UNITED STATES PATENT AND TRADEMARK OFFICE

APPLICATION NO.	FILING DATE	FIRST NAMED INVENTOR	ATTORNEY DOCKET NO.	CONFIRMATION NO.
10/015,701	12/17/2001	Kyeong Jin Kim	8733.479.00	6382

Office Action Summary	Application No. 10/015,701	Applicant(s) KIM, KYEONG JIN	
	Examiner Timothy L Rude	Art Unit 2871

DETAILED ACTION

FIG. 3A

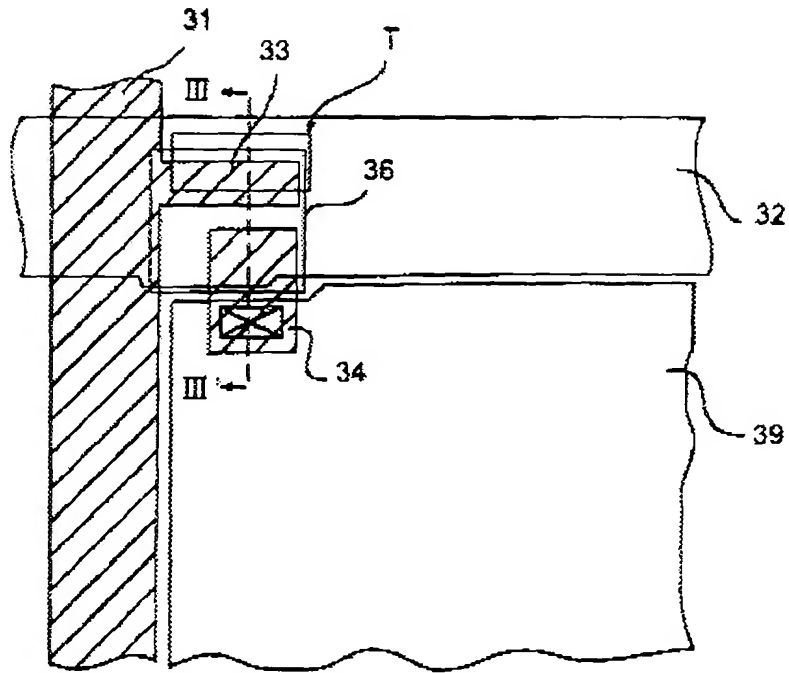
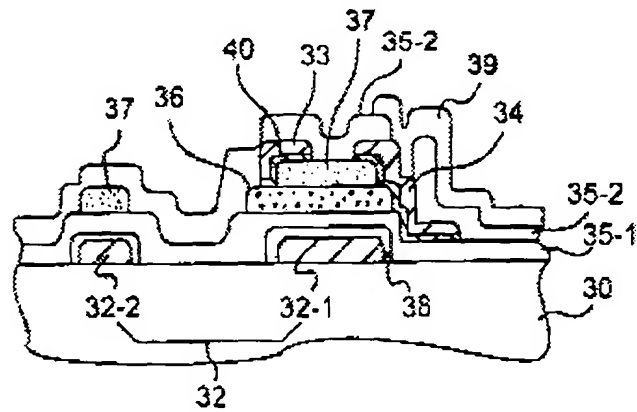
As to claims 1, 7, and 10, Ohe discloses (Abstract and entire patent) a method of forming a liquid crystal display device comprising: forming an L-shaped thin film transistor (Figure 3A, col. 6, lines 32-37) and a pixel electrode, 39, on a first substrate.

FIG. 5

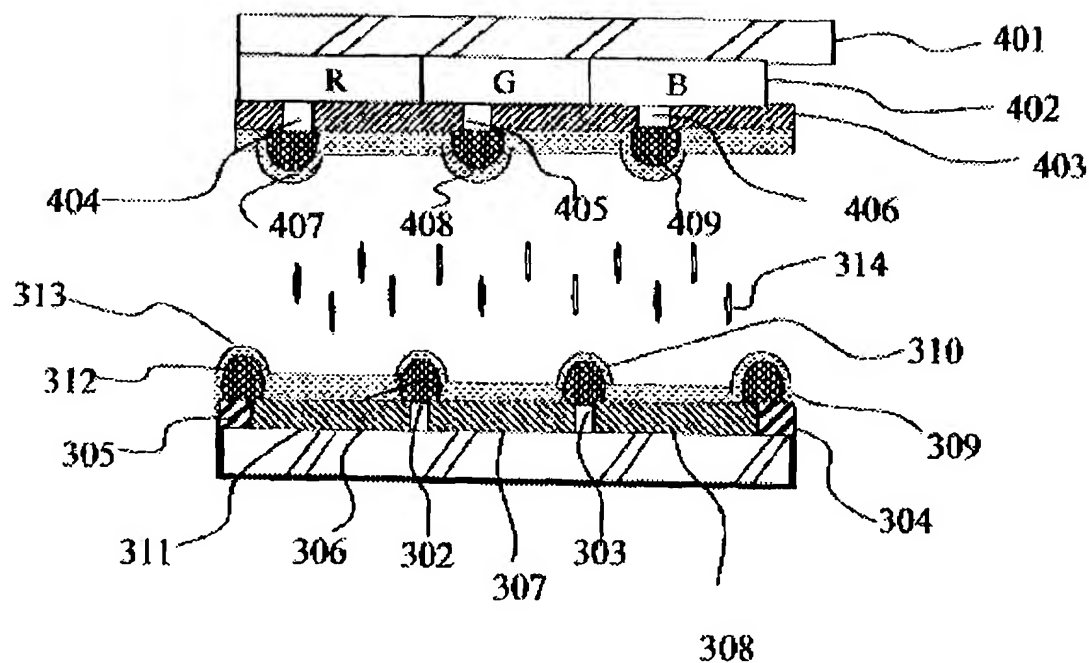
Liu teaches (Abstract and entire patent) forming bumps, 311 and 409 (Applicant's dielectric frame) on both substrates (Figure 5, col. 5, lines 45-57, and col. 5, lines 35-44) having a first height and a sealant having a second height (not shown) such that the sealant is taller than the dielectric frame as is evidenced by the gap between the dielectric frames and the opposed substrate (Figure 5) to comprise a multi-domain display with wide viewing angle (col. 2, lines 36-46).

As to claim 13, Liu, as combined above, teaches a method wherein the dielectric frame, 409, is formed on the common electrode, 403 (Figure 5).

As to claim 14, Liu, as combined above, teaches a method further comprising forming an alignment layer, 313 and 407, on the first and second substrates (Figure 5).

FIG.3

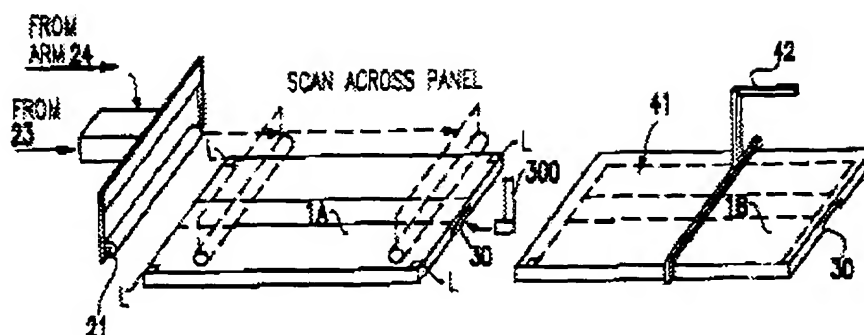
Von Gutfeld teaches dispensing liquid crystal on the first substrate (Abstract and entire patent); and attaching the first and second substrates to each other to provide a simplified and more efficient method for filling an unassembled LCD panel that is less costly (col. 2, lines 25-34).

FIG. 2

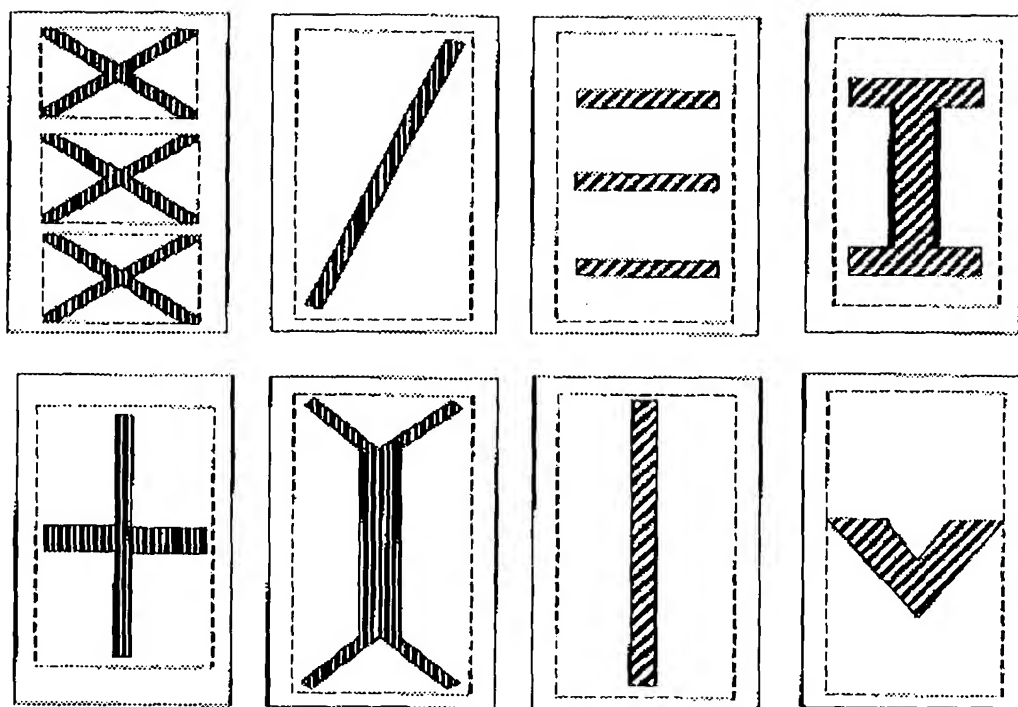
As to claim 5, Liu, as combined above, teaches in Figure 2 a method wherein the electric field inducing window has a slit shape or a hole shape.

FIG. 1 (Prior Art)

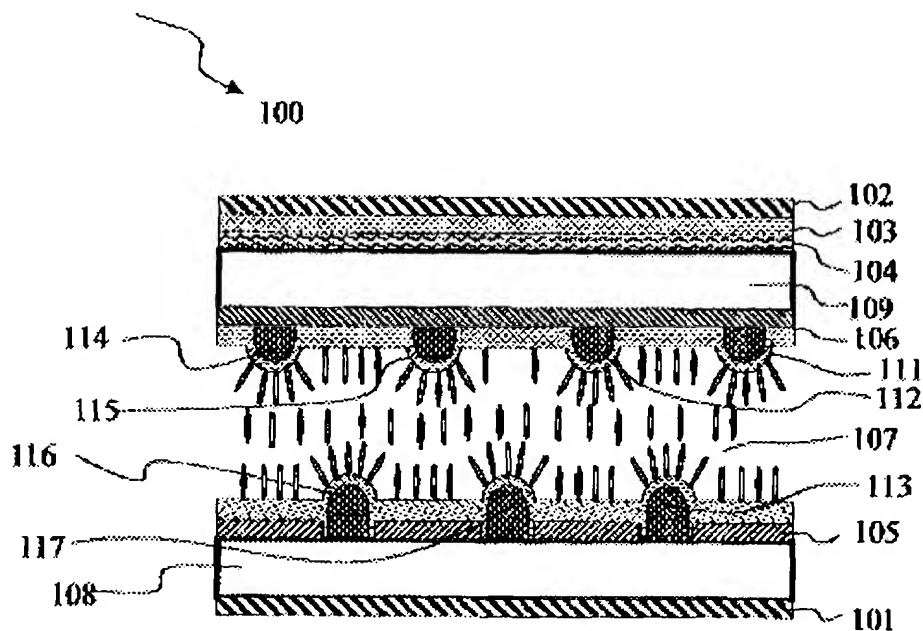
As to claim 9, Liu, as combined above, teaches Prior Art in Figure 1 that shows dielectric frames drive the liquid crystal in various directions.
